# Agenda

Planning Decisions Committee 7.30pm, Tuesday 22 October 2024 Richmond Town Hall

Reference	D24/359840	0	
Author	Kathryn Po	und - Manager Statutory Planning	
Authoriser	Manager St	atutory Planning	
Disclosure	preparation	ser, having made enquiries with members of staff involved in the of this report, asserts that they are not aware of any general or nflicts of interest in relation to the matters presented.	
Ward:		Melba	
Proposal:		Development of a multi-storey building comprising office, use of ground floor as shop, and a reduction of car parking requirements.	
Existing use:		Three storey commercial building and at grade car parking.	
Applicant:		101CSC Pty Ltd c/- Planning & Property Partners Pty Ltd	
Zoning / Overlays:		Commercial 2 Zone (C2Z)	
		Development Contributions Plan Overlay – Schedule 1 (DCPO1)	
Date of Applic	ation:	14/08/2024	
Application Number:		PA2403110 (DTP reference) PPE24/0515 (Council reference)

Figure 8: Proposed building height with approximate preferred maximum building height shown as red line (left) and Artiste impression showing taller built form to the rear of the site on Kelso Street (right), source: applicant materials

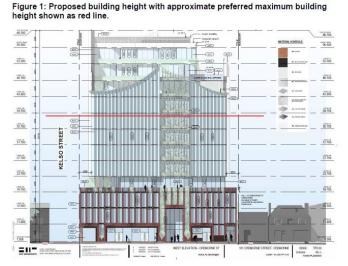
- 133. The subject site is in Precinct 'CW-D' in the Plan 1 Building heigh, Setbacks and Interface Plan.
- 134. Pursuant to the Draft DDO51, a permit is required to construct a building or construct or carry out works (there are some exemptions that are not relevant to this application).
- 135. The DDO51 has mandatory requirements and discretionary requirements.

- (f) The upper levels (above the podium) on the southern and eastern elevations setback 4.5m from the boundaries; and
  - (g) Provision of a public realm plan.

#### BUILDING MATERIALITY

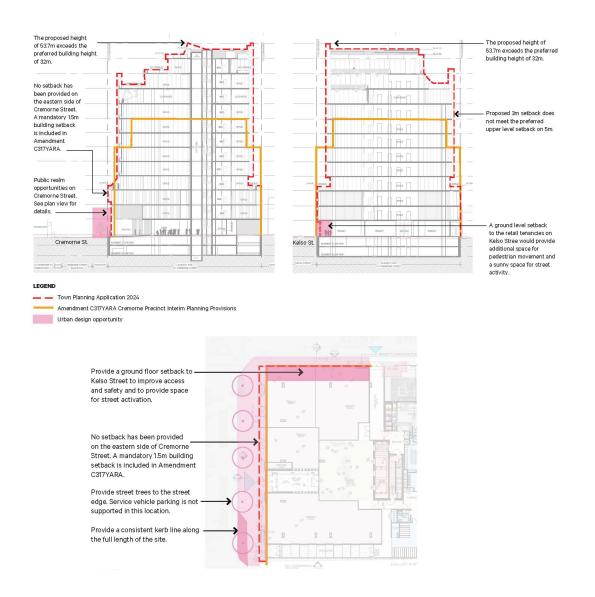
I support the choice of materials and the clear differentiation between the lower and upper levels of the building. The use of brick for the lower floors and lighter detailing for the upper levels is a positive aspect of the building design. While the scalloped roof design offers a distinctive roofline, I would also be amenable to a more simplified building form.

At the ground level, incorporating integrated seating elements is recommended, potentially as part of the planter boxes, and increasing greening within the streetscape.

### Figure 1: Proposed building height with approximate preferred maximum building height shown as red line.

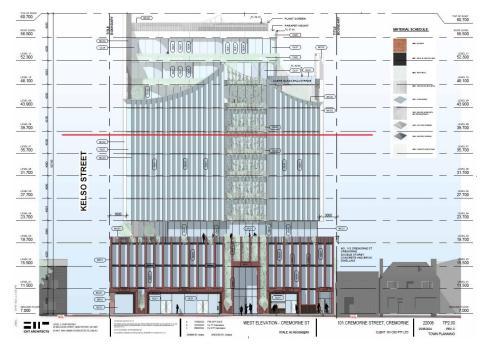
The proposed development substantially exceeds the preferred building height in DDO51 of 32m (see Figure 1).

A key concern is the scale of the development on Kelso Street. The development is substantially higher in the rear than on Cremorne Street - 49.5m at the rear compared with a height of 36.9m at Cremorne Street (see Figure 2).

A height of 49.5m on the Kelso Street frontage will overwhelm the street, especially when considering the minimal street setback and 3m upper level setbacks.

The proposed height in combination with a lack of adequate upper level setbacks and street wall setbacks visually dominates the streetscape.

Figure 5: Proposed upper level setbacks to Cremorne Street (Red line show upper level setback in DDO51)

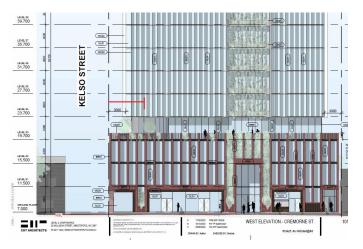
Strategic Planning agrees with advice from Urban Design that a consistent setback should also be provided to Kelso Street. This is necessary to create a usable width along the Kelso Street frontage (see Figure 3).

#### Figure 6: Extent of overshadowing between 10am and 11am

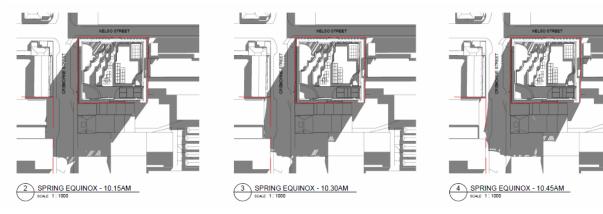
The shadow diagrams show the development can achieve this. Overshadowing of the opposite footpath only occurs between 10am and 11am (see Figure 6).

Figure 1: Indicative Public Realm and Streetscape Layout (subject to further investigations)

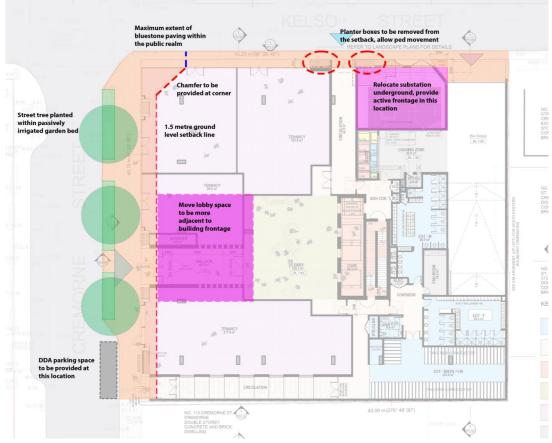
- A central commercial entrance is proposed along Cremorne Street, with the generous lobby space recessed centrally within the building. This space could contribute to a more active public realm interface if programmed closer to the street edge on Cremorne Street (refer Figure 1).

supported. An increased setback must be provided along the whole site boundary to Cremorne Street. This should be at least 1.5 metres but can be extended further to provide additional publicly accessible space particularly at the building entrance and this space can connect through to a repositioned lobby area.

- Increased setback area can be utilised for outdoor dining, bespoke integrated seating as well as allowing provision of visitor bike parking within the site boundary.
- Corner chamfers are required under the Cremorne UDF at busy intersections. The intersection of Cremorne and Kelso Streets is currently very busy and pedestrians volumes will increase considerably with this development. Considering the space constraints here where pedestrians wait at crossing points, extra space provided by a chamfered corner at this point will substantially improve pedestrian amenity.

- The following streetscape enhancements are recommended. Refer to indicative layout at Figure 1.
  - 3 street trees
  - 3 planter beds
  - 2 public seats (minimum)

- The current design features bluestone paving along both the Cremorne Street and Kelso Street frontage. Bluestone paving is only supported at Cremorne Street. Paving should only extend down Kelso Street until indicated on the UD mark up (figure 1 above). Kelso Street frontage should otherwise be asphalt footpath within the public realm.

Streetscape enhancements in form of street trees and landscaping must be detailed on a **Public Realm and Streetscape Plan** (refer to indicative layout at Figure 1).
